Amendment to the Drawings:

Application No.: 10/714,498

Annotated Marked-Up Drawing

Fig. 1 (Prior Art)

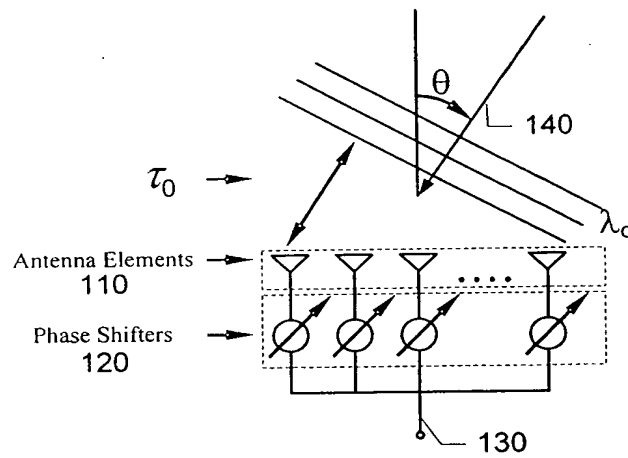
In response to the Examiner's objection to the drawings, please find attached hereto a Replacement Sheet and an Annotated Drawing Sheet for Figure 1 which adds the caption "Prior Art" to Figure 1.

As an initial matter, Figure 1 was objected to in the Office Action because it did not include the caption "Prior Art". Applicants have attached hereto a Replacement Sheet and an Annotated Drawing Sheet which add the caption "Prior Art" to Figure 1. Accordingly, entry of the revised Figure 1, and reconsideration and withdrawal of the objection thereto, are respectfully requested.
